COMMISSION ACTION

NCPC File No. 6265

LINCOLN MEMORIAL
LINCOLN MEMORIAL CIRCLE SECURITY IMPROVEMENTS, EAST SIDE –
BARRIER LOCATION
Washington, DC

STAFF RECOMMENDATION

Proposed barrier line around the Lincoln Memorial

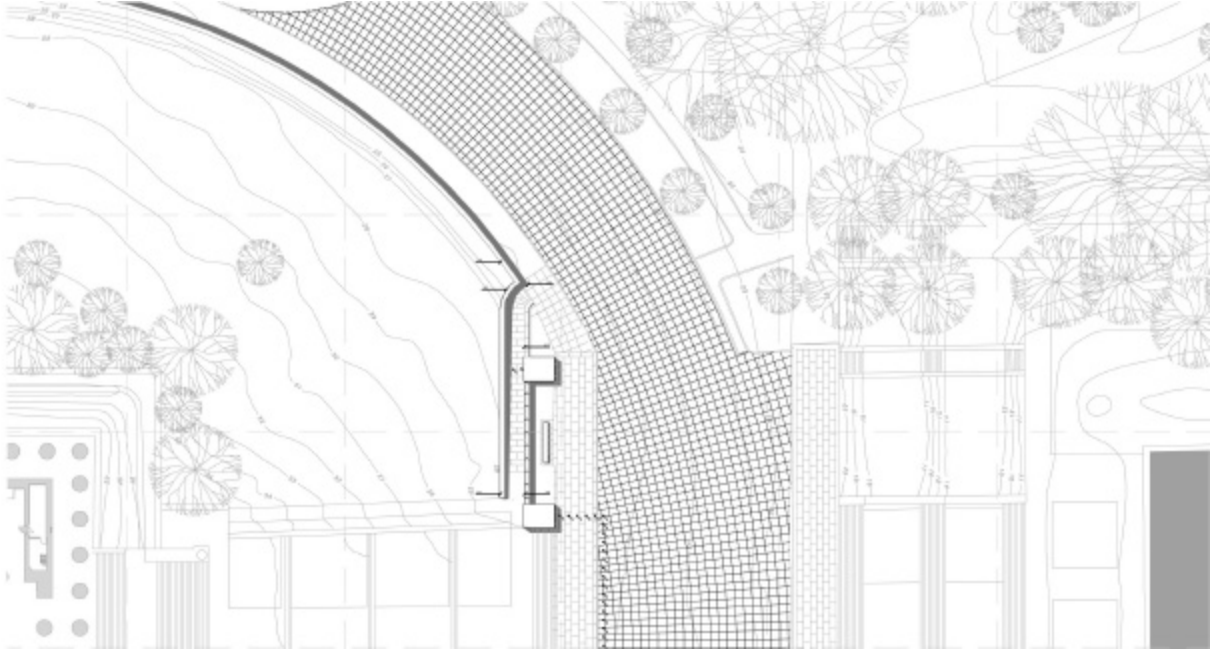
The “inner circle” placement of the bollards on the east side of the Lincoln Memorial has been advocated by Commission staff for two years as the location least intrusive on the Mall vista from the memorial chamber and the one that best preserves the openness of the iconic east-west vista. *But the staff has always acknowledged that the close-in location is not a panacea. Not only does it have its own visual and physical impacts, but it heightens the necessity of the best-possible design and placement of the security elements because of their proximity to the memorial.* In particular, staff recommends that the following elements be studied further (and alternatives proposed) before they can be endorsed:

- The bollard design and form as viewed against the backdrop of the memorial columns, and in relation to the austere, rectilinear plinths and foreground elements.
- The precise placement of the bollard line in relation to the curb of the granite sidewalk, and the returns of the line in relation to the plinths on either side of the staircase. This should be studied in concert with additional bollard designs.
- The cartway pavement material as well as its scale (not only in relation to the character of the elements at the base of the memorial staircase, but in relation to the design and spacing of the bollards) and if a different, special material should be used in the axial approach to the memorial staircase.

Given the slower speed of any vehicle that could potentially climb the stairs from the Reflecting Pool, staff recommends that NPS restudy the bollard spacing requirements. NPS is using a requirement of spacing bollards at 4 feet on center (measured from the structural cores of adjacent bollards). Staff believes that the bollards could be placed farther apart. Each single bollard is designed and installed to stop a vehicle moving at a fast rate of speed. In light of the actual slower traveling speed of any vehicle that reached the plaza, staff recommends that NPS study a wider spacing in order to reduce the number of bollards, limit the negative effect of the barrier in front of the memorial, and improve the experience for pedestrians.

- The placement of a bollard line in the cartway of Lincoln Memorial Circle, at the inner edge of the circle near the base of the memorial stairs.
- The extension of the retaining walls toward the ramps and their continuation along the back of the ramps as generally shown in Scheme 2A of the submitted revised concept.

- The precise placement of the bollard line in relation to the granite curb edge;
- The placement of the return of the bollard line in relation to the plinths at the base of the staircase;
- The design and spacing of the bollards;
- The pavement material and layout in the former cartway of Memorial Circle.

Elevations showing the extension of the new security retaining wall now under construction around the Circle and its return along the inner edge of the ramp, all behind the original plinth blocks and connecting retaining.

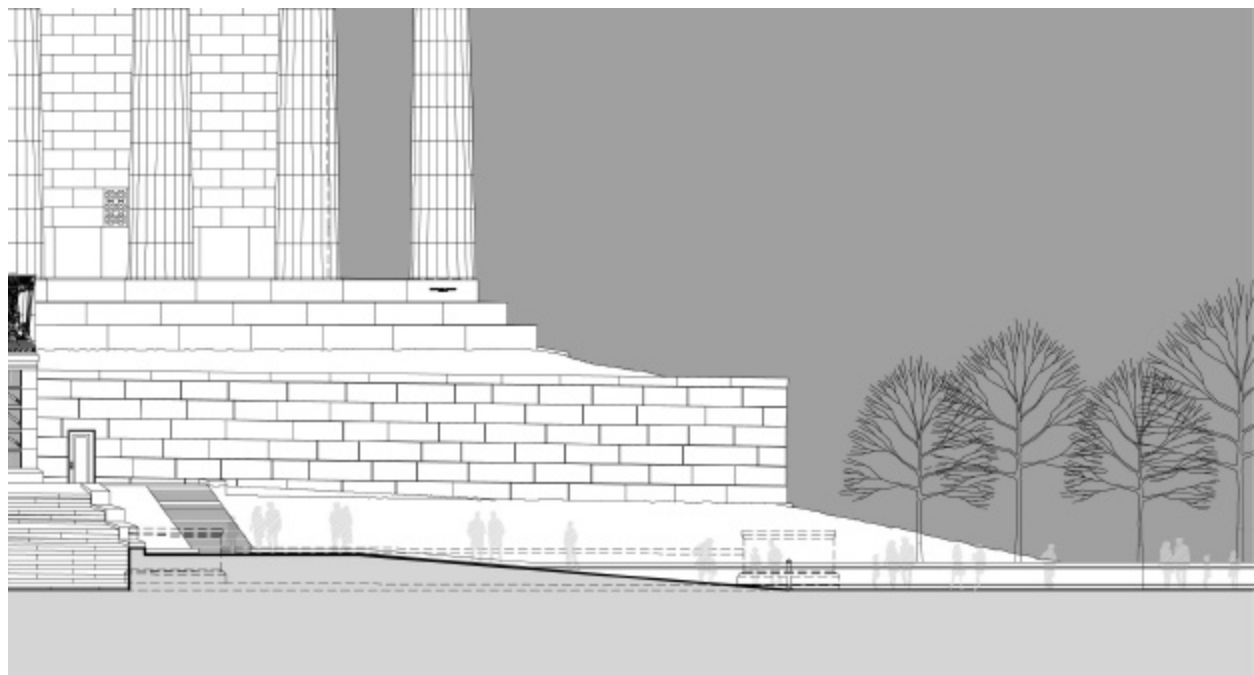
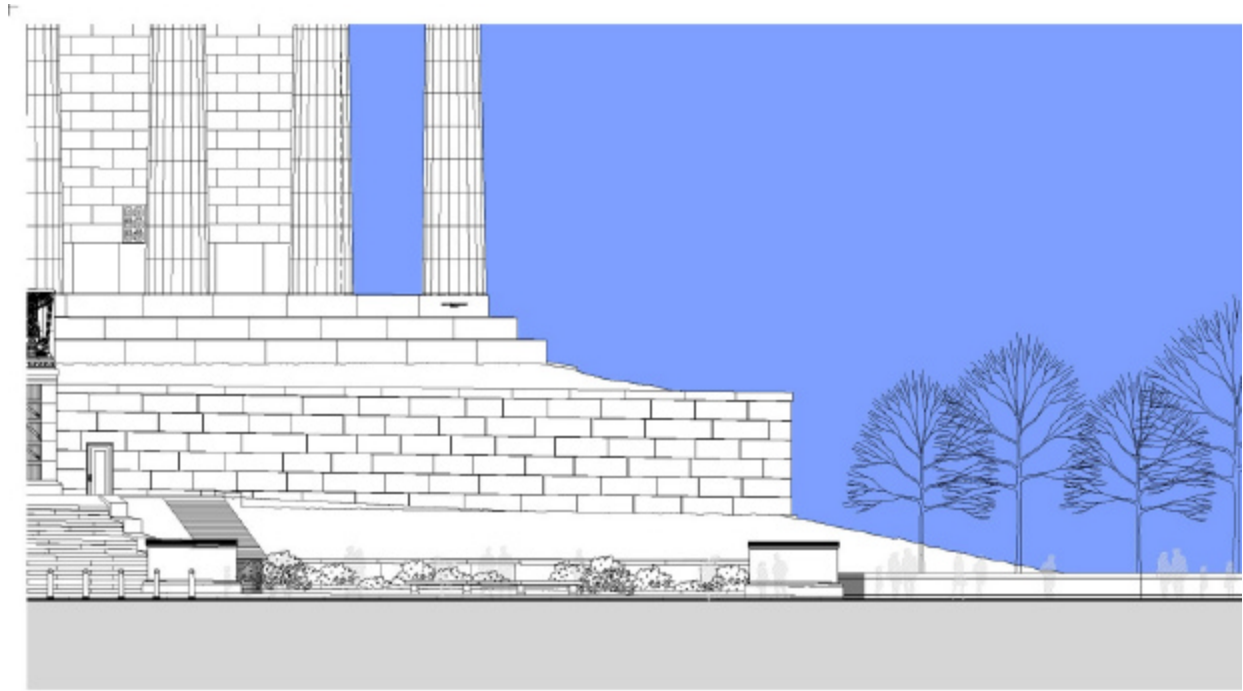
The staff recommends that the retaining wall extensions continue at the same height as the portion of the wall now under construction, turn at the inner ends of both ramps and continue at the same height along the inside or rear of the ramps until they die into the slope. All review agencies appear to be in agreement about this approach. NPS and its design team are studying the site conditions and will provide more detailed information at the next phase of Commission review.
